MASTER GRADING AND DRAINAGE PLAN MEGERDICHIAN SENIOR CENTER

8849 EAST CHOLLA STREET, SCOTTSDALE, ARIZONA 85260

MASTER GRADING AND DRAINAGE PLAN

MGD2
OF 2

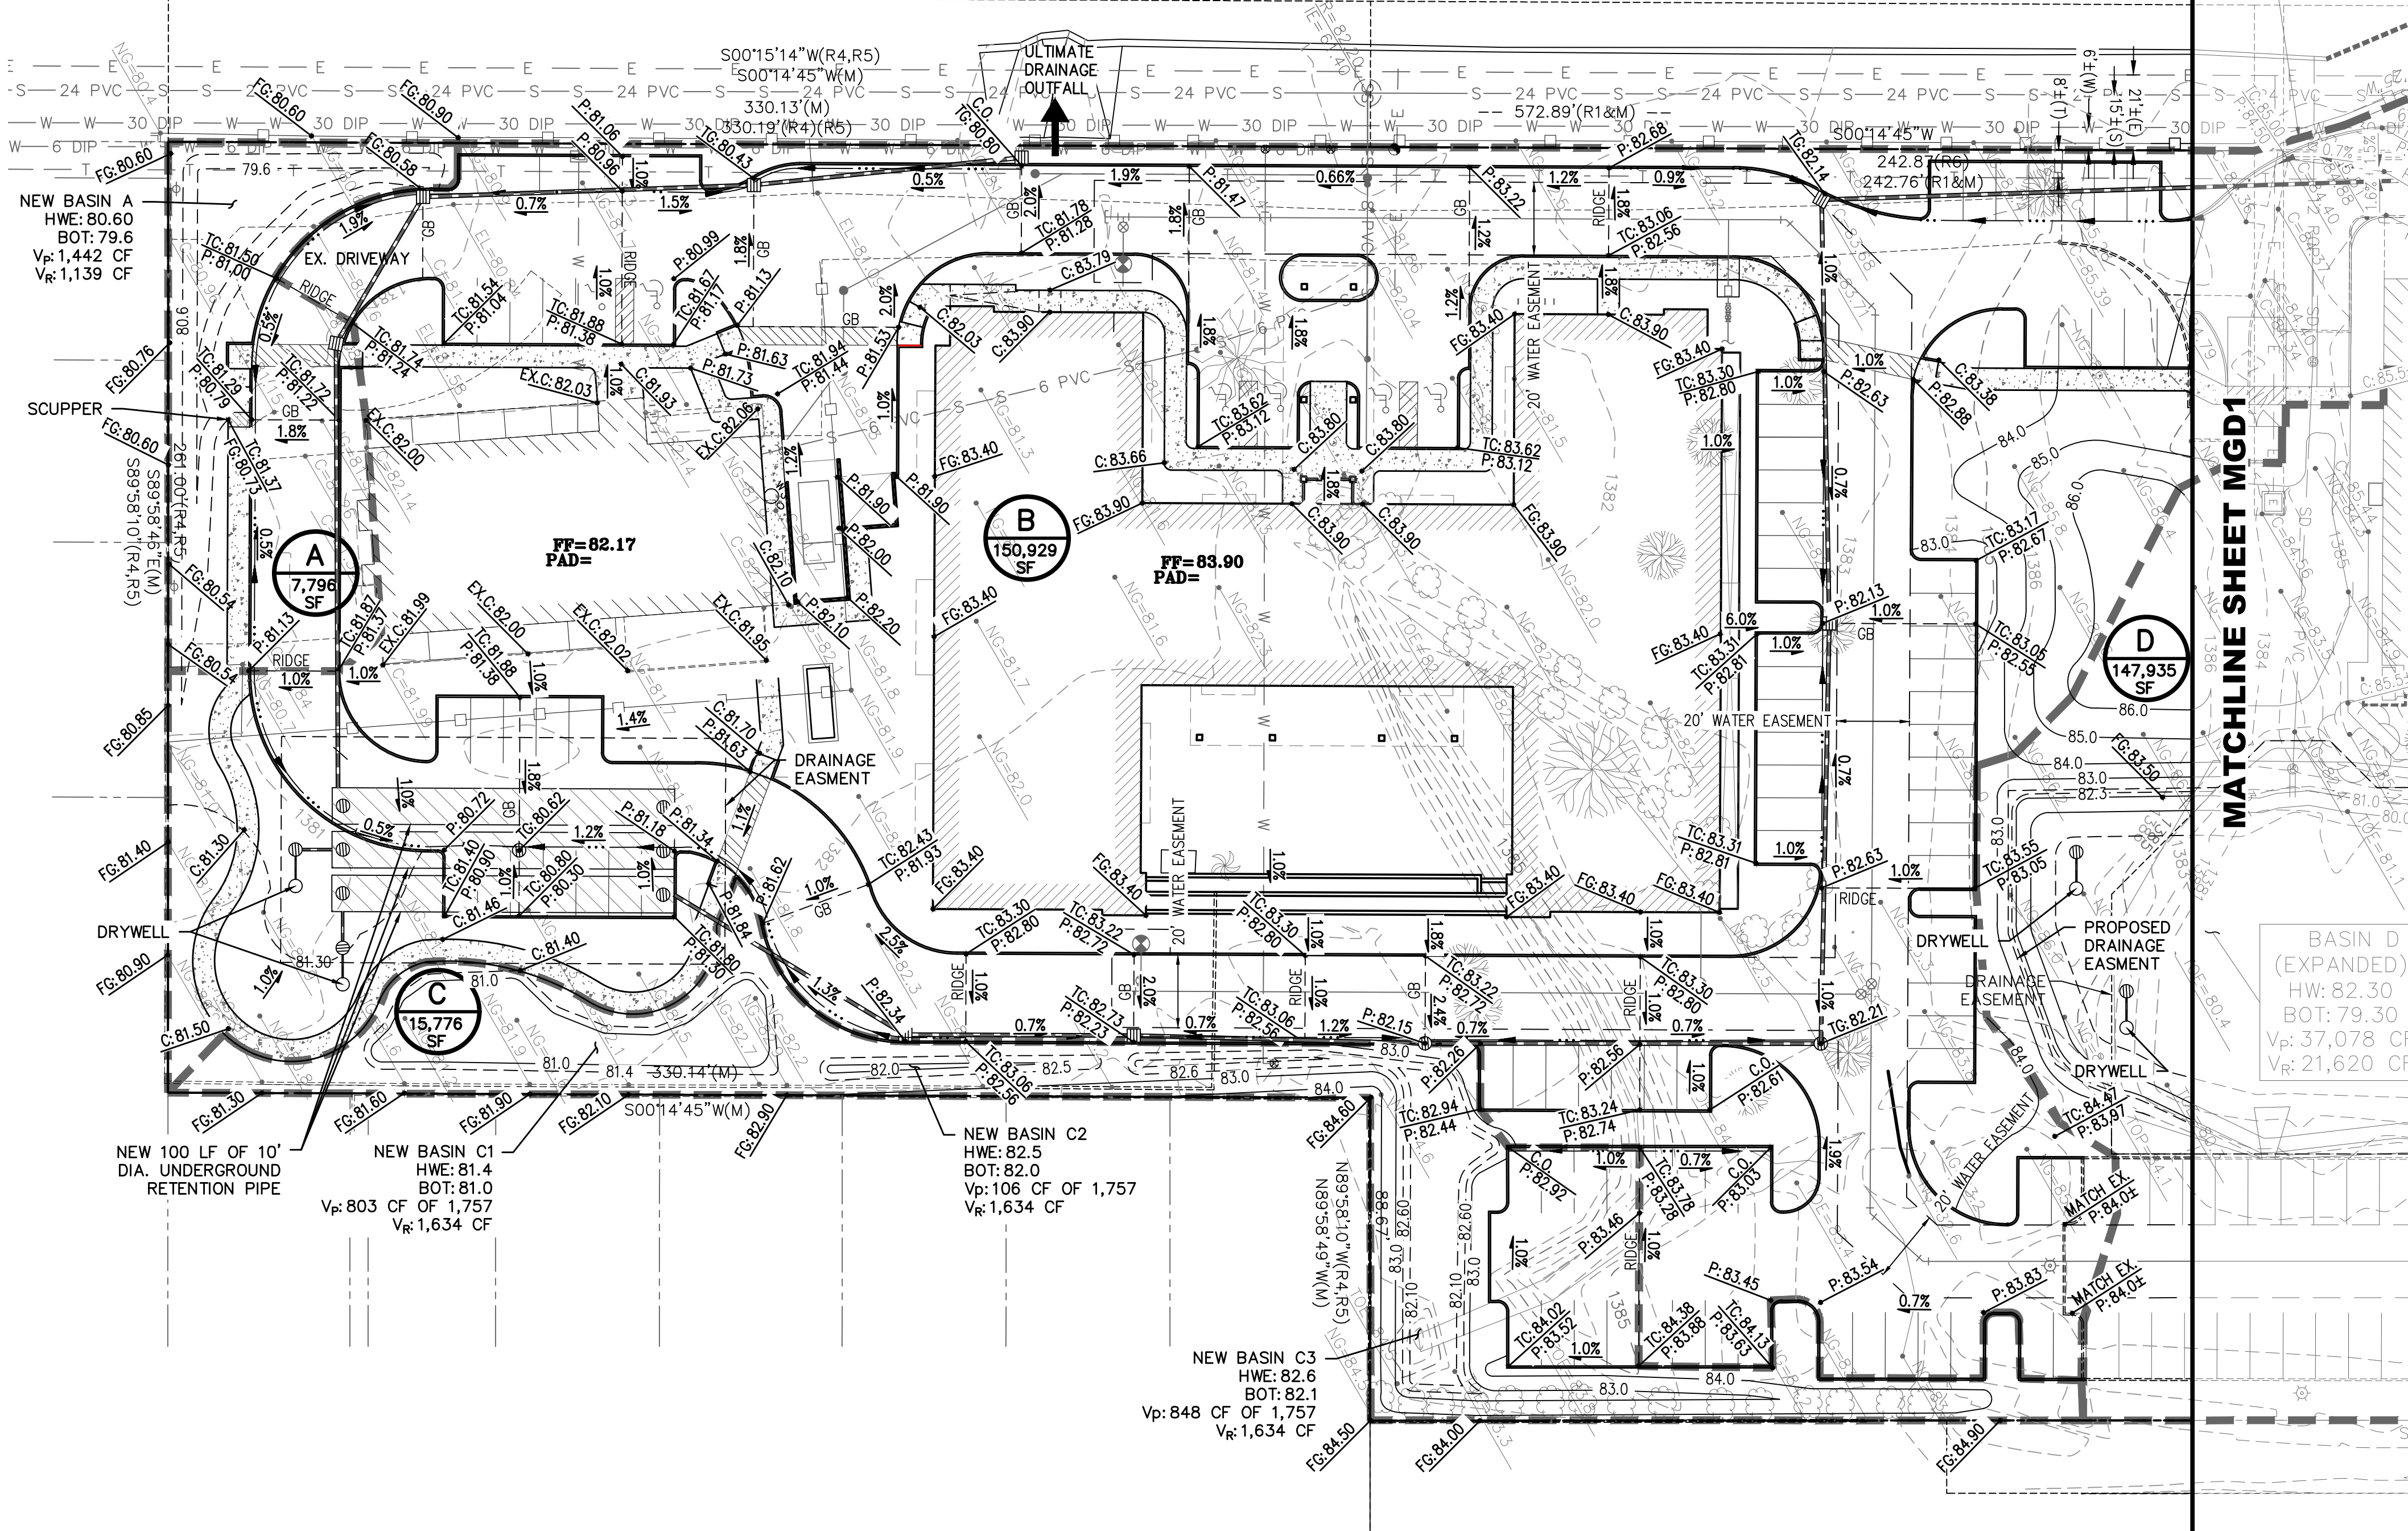
1. THE FINAL DRAINAGE REPORT SHOULD NOTE THAT THE PROPOSED UNDERGROUND STORMWATER STORAGE TANKS (USSTS) MUST MEET THE CITY'S USST POLICY IN SECTION 4-1.202 OF THE CITY'S DESIGN STANDARDS & POLICIES MANUAL (DSPM), WHICH INCLUDES BUT IS NOT LIMITED TO THE FOLLOWING:
(PLEASE REVIEW THE REFERENCED SECTION COMPLETELY TO ADDRESS ANY OUTSTANDING APPLICABLE ITEMS. DISCUSS AND INCORPORATE IN THE DRAINAGE REPORT AS APPLICABLE).

- A. THE OWNER MUST DEDICATE A PUBLIC DRAINAGE EASEMENT OVER THE USST, WITH NO MAJOR VEGETATION SUCH AS TREES WITHIN THE EASEMENT. AT A MINIMUM, THE EASEMENT SHOULD EXTEND AT A PROJECTED SLOPE OF 1:1 FROM THE BOTTOM OF THE PIPE.

- B. THE USST MUST HAVE AT LEAST A 75-YEAR LIFE, INCLUDING THE LINING AND COATING.
 - C. THE USST MUST DRAIN BY GRAVITY.
 - D. SPECIFY MAG SUPPLEMENTAL STANDARD DETAIL 2554 FOR CORRUGATED METAL PIPES.

- E. A MINIMUM OF TWO ACCESS POINTS MUST BE PROVIDED FOR EACH USST.
 - F. AN OPERATIONS AND MAINTENANCE (O&M) MANUAL MUST BE PREPARED FOR THE SYSTEM PRIOR TO APPROVAL OF FINAL PLANS.

- G. FINAL PLANS MUST INCLUDE SIGNS AT EACH END OF THE USST.
 - H. A SIGNED AND NOTARIZED OWNERSHIP AND RESPONSIBILITY STATEMENT MUST BE PROVIDED PRIOR TO APPROVAL OF FINAL PLANS.

- I. ADD THE REQUIRED WARNING SIGNS
